SALISBURY PARK NORTH PHASE 1

TOWN OF PARKER

SITE PLAN

SITE PLAN SUBMITTAL
Page 1 of 311

Drawing
**OVERALL UTILITY PLAN
(FINAL)**

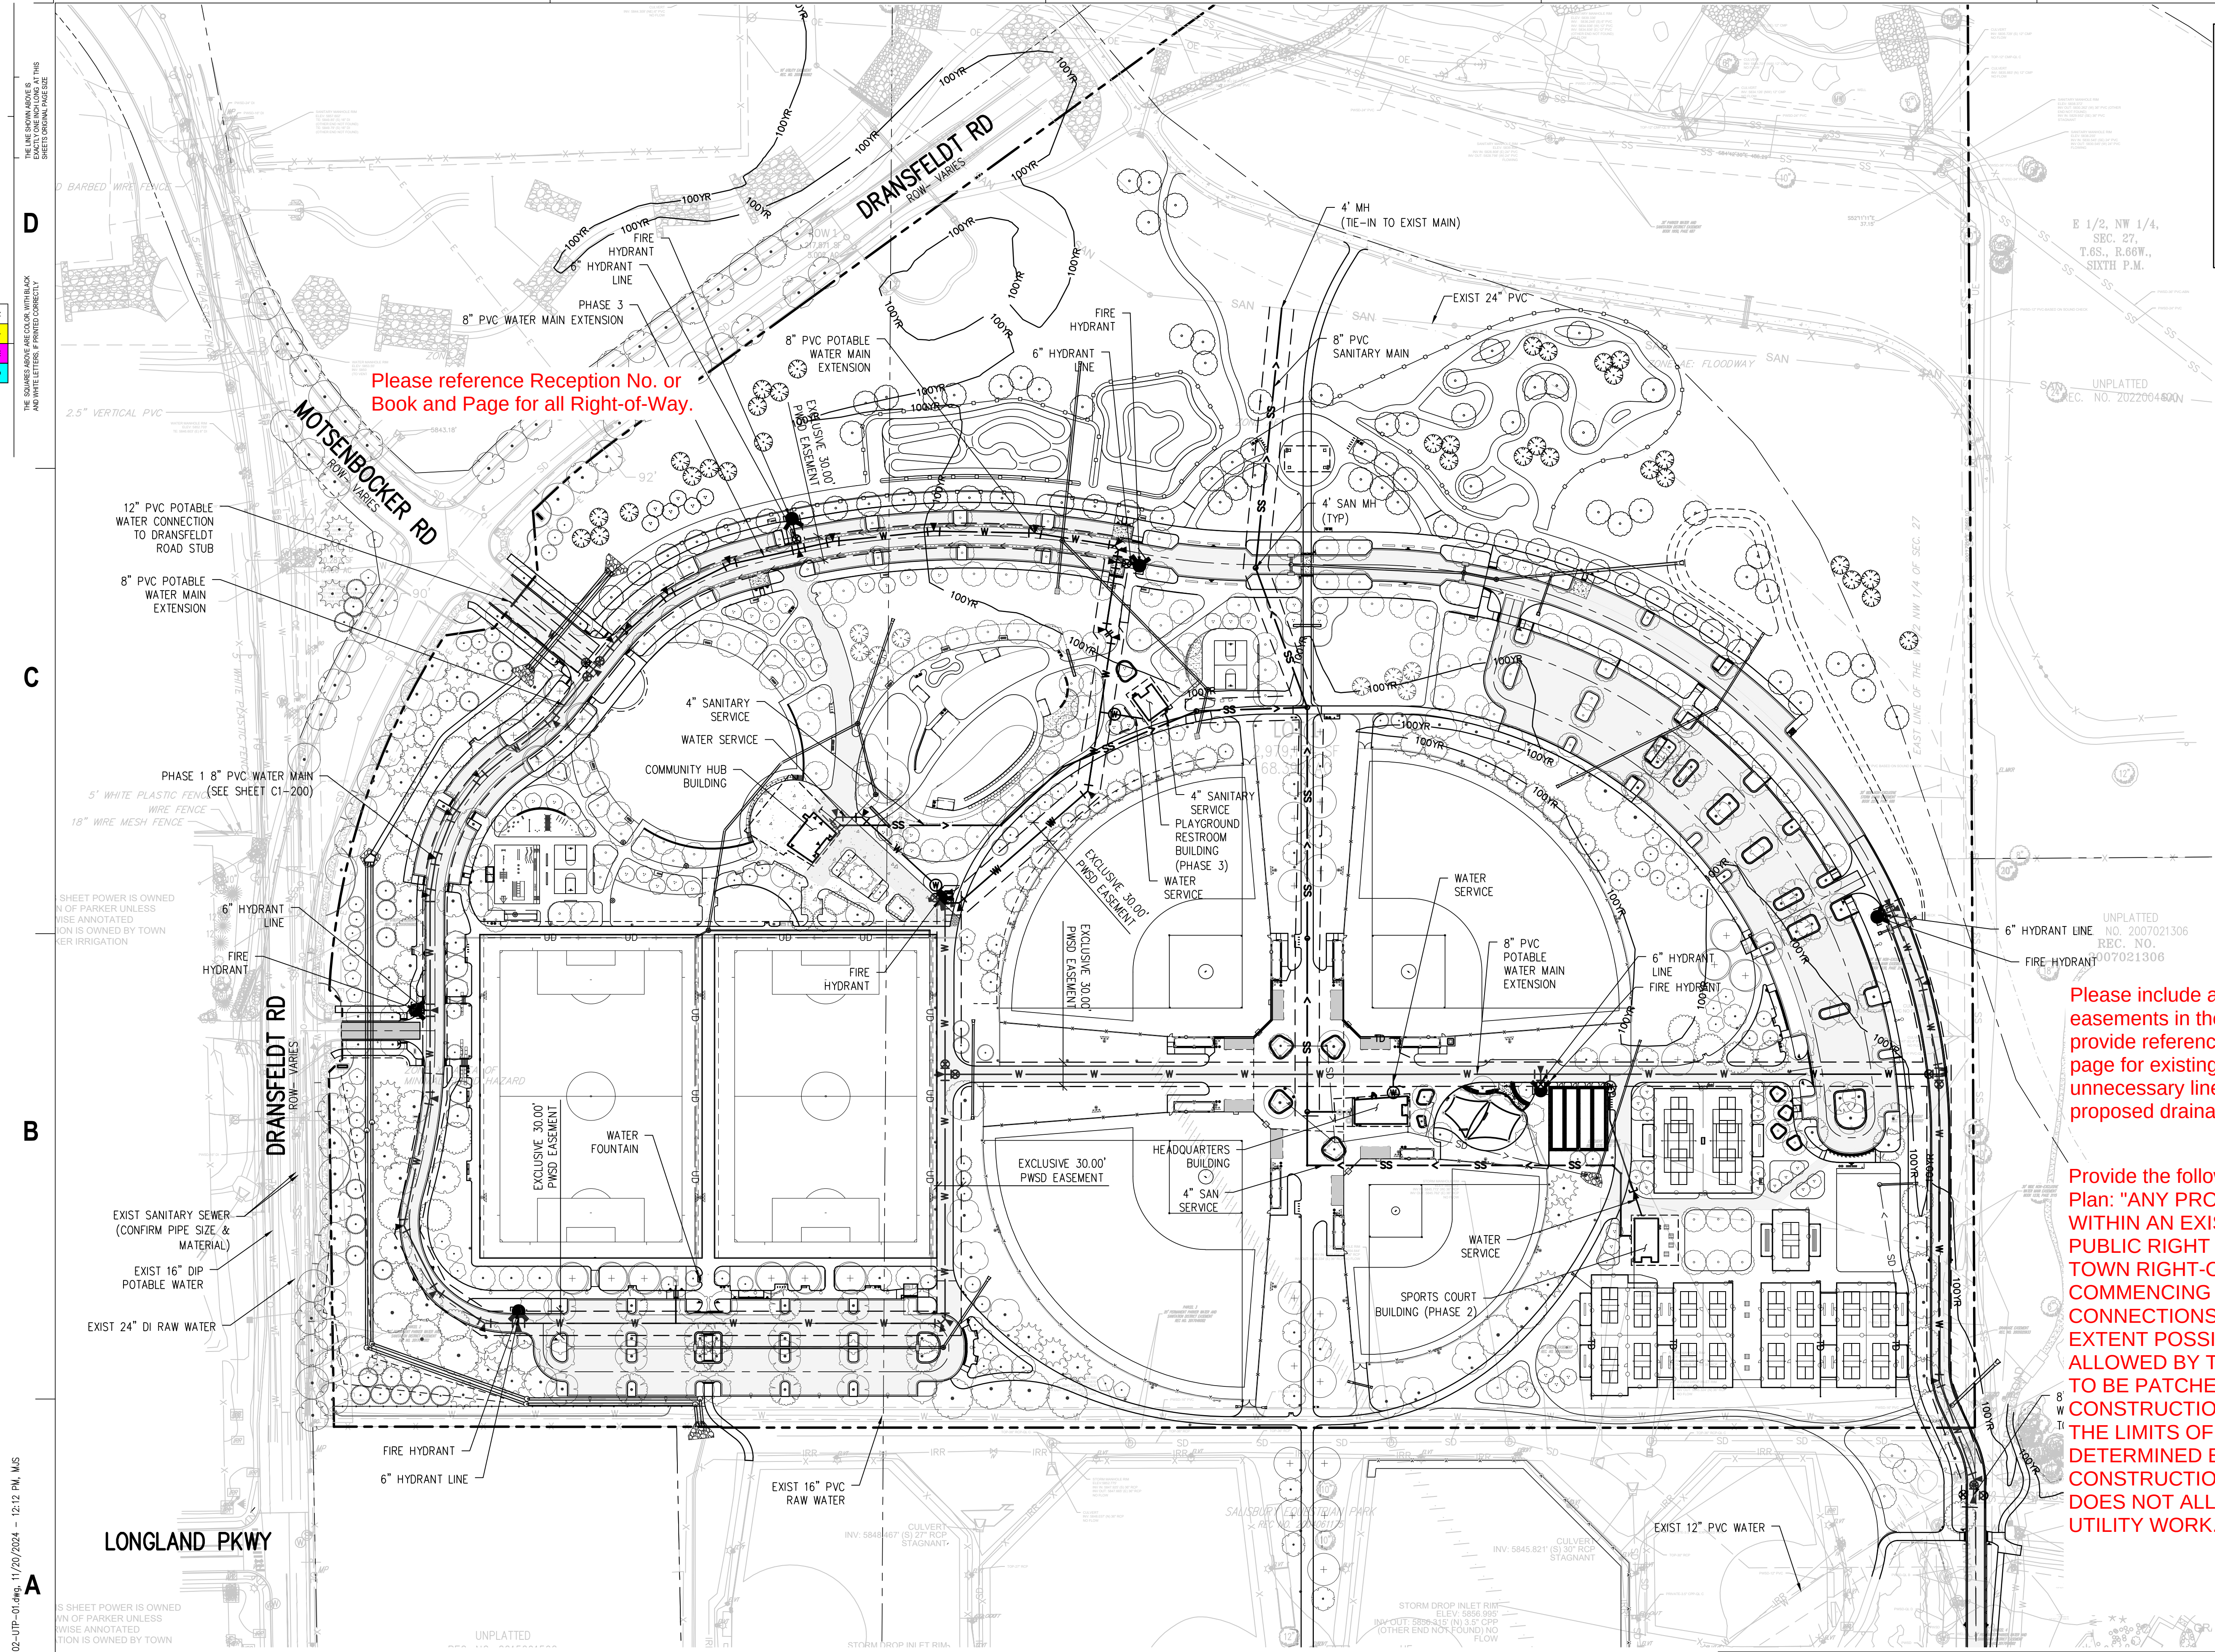
Please include all proposed and existing easements in the Overall Utility Plan and provide reference reception no. or book and page for existing easements. Please remove unnecessary linework for clarity and include all proposed drainage easements.

Provide the following note on the Overall Utility Plan: "ANY PROPOSED UTILITY CONNECTION WITHIN AN EXISTING ROADWAY WITHIN PUBLIC RIGHT OF WAY WILL REQUIRE A TOWN RIGHT-OF-WAY PERMIT PRIOR TO COMMENCING WORK. THE TOWN REQUIRES CONNECTIONS TO BE BORED TO THE EXTENT POSSIBLE, AND ANY STREET CUT ALLOWED BY THE TOWN WILL BE REQUIRED TO BE PATCHED ACCORDING TO THE TOWN'S CONSTRUCTION STANDARDS AND DETAILS. THE LIMITS OF PATCHING WILL BE DETERMINED BY THE TOWN AT THE TIME OF CONSTRUCTION. THE TOWN OF PARKER DOES NOT ALLOW ROADWAY CLOSURES FOR UTILITY WORK."

All fire hydrants shall be installed according to water utility standards. The number and locations of the fire hydrants as shown on the Overall Utility Plan are correct as specified by the Town of Parker, Community Development Department.

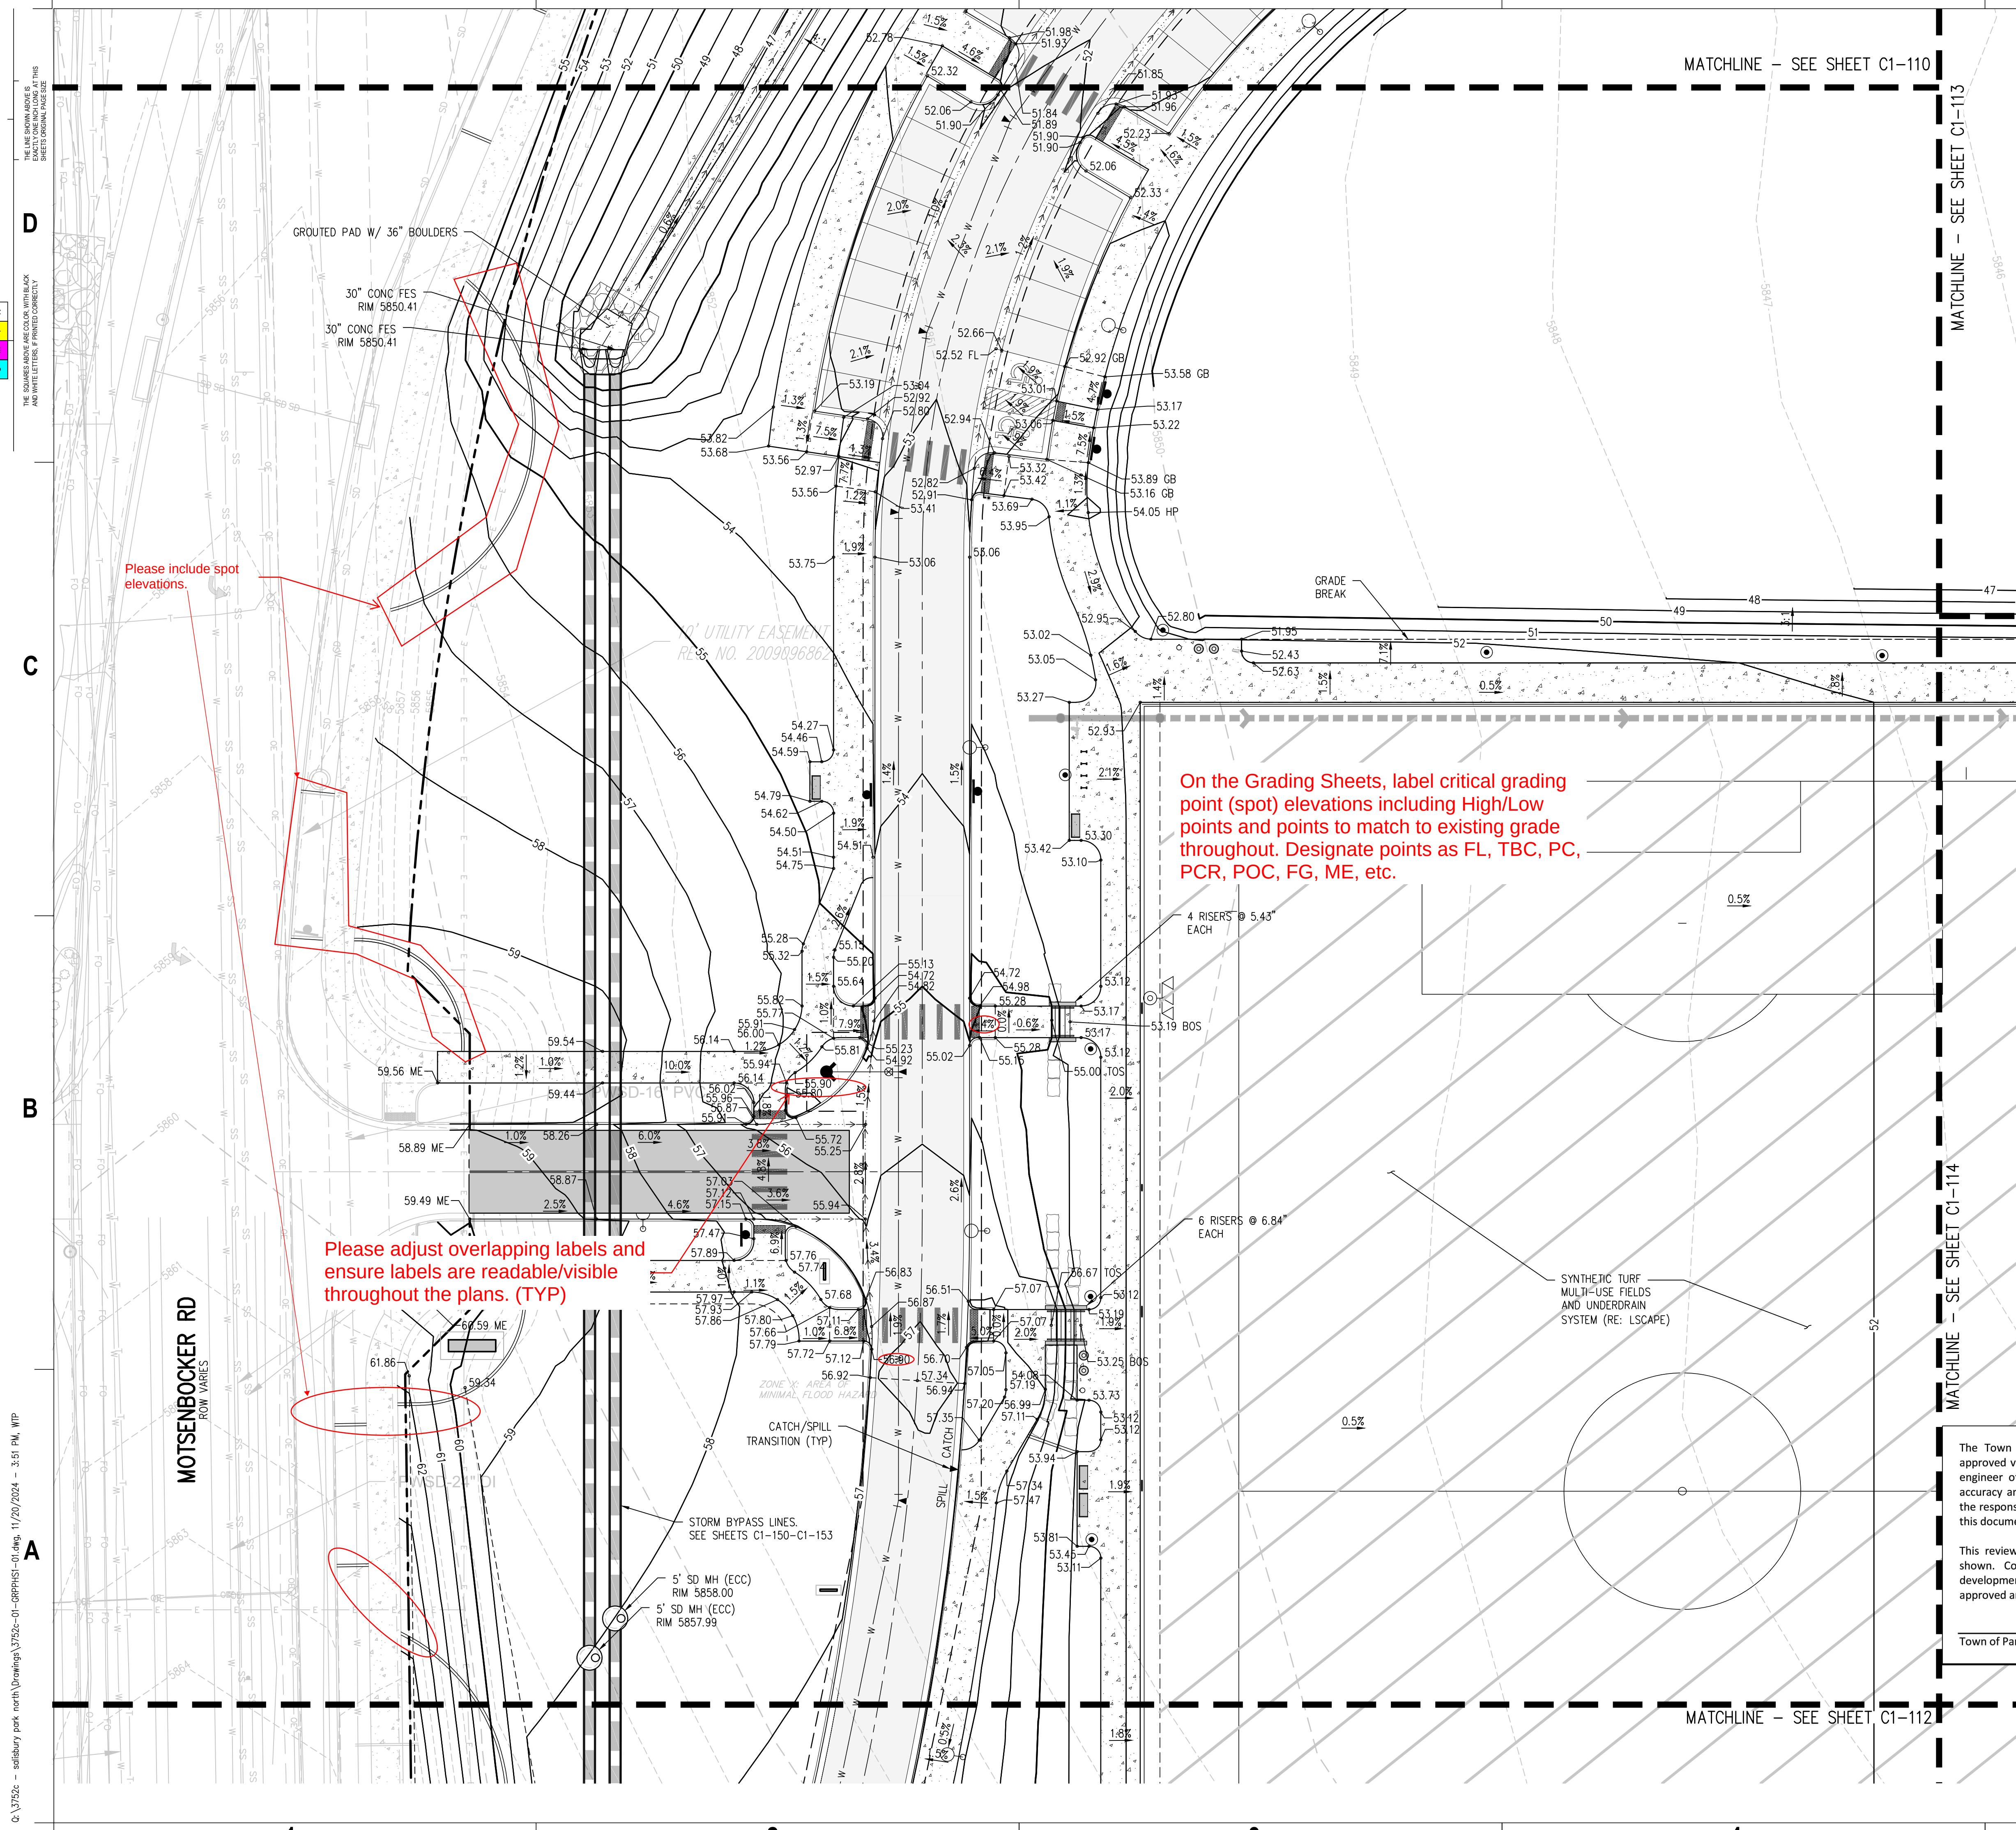
Please adjust overlapping labels and ensure labels are readable/visible throughout the plans. (TYP)

Please label all private driveway/roadway as "Private" throughout the plans.

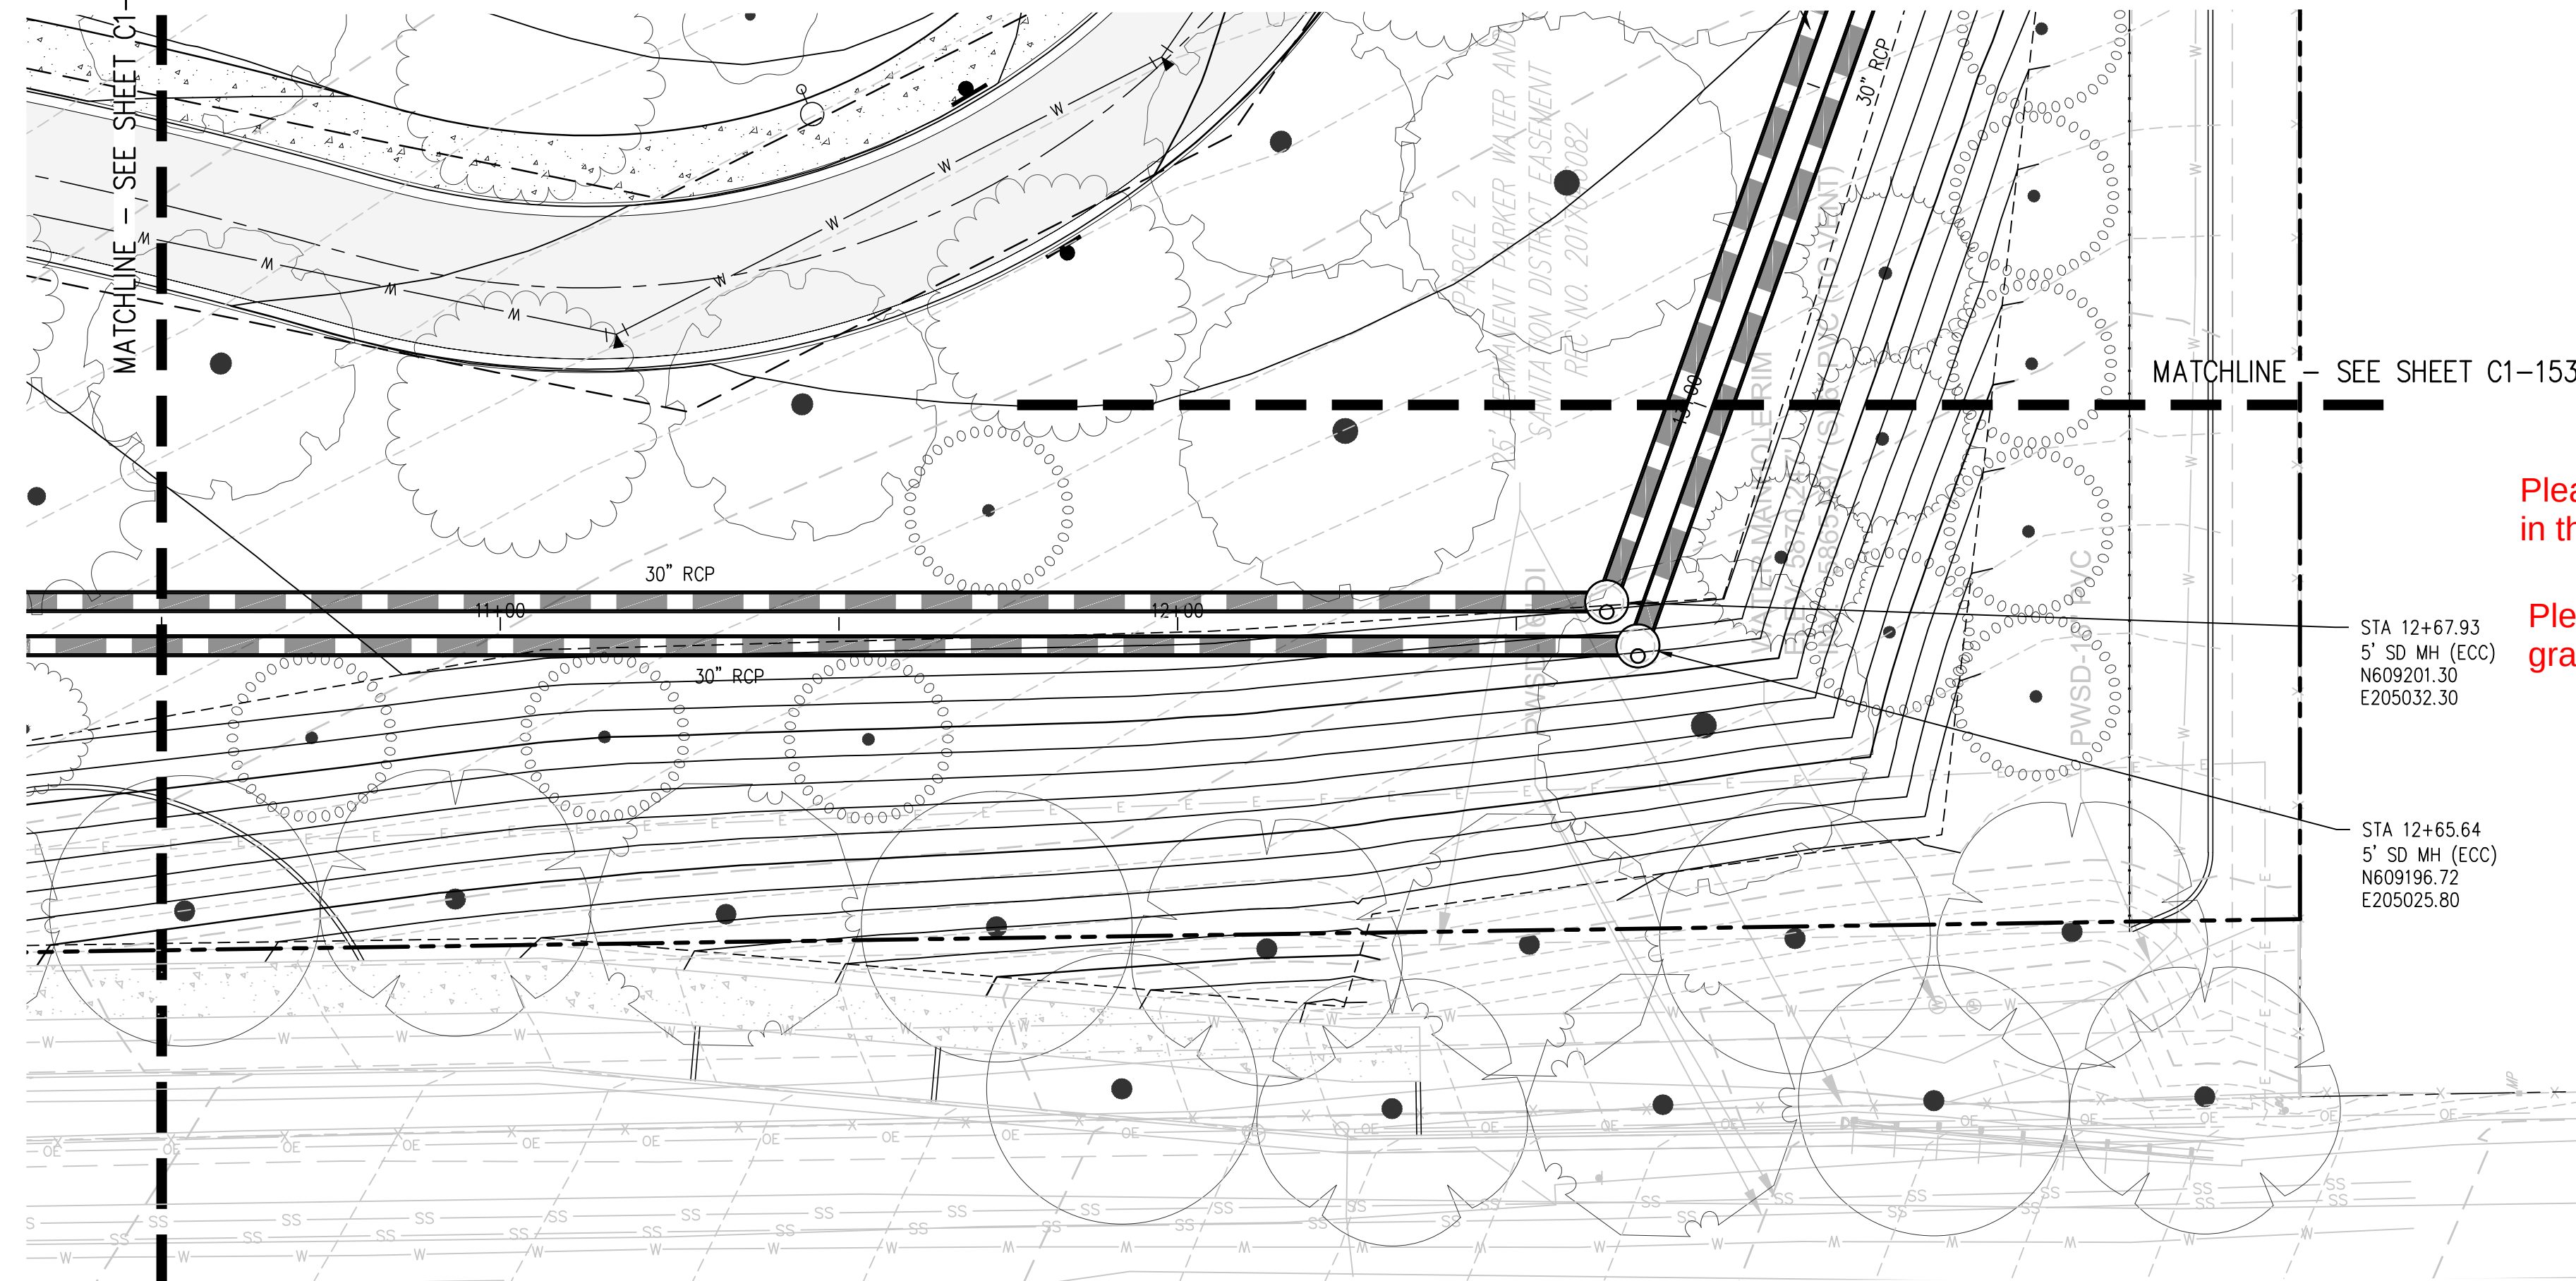
Please include existing and proposed grade contour labels and slopes. (TYP)
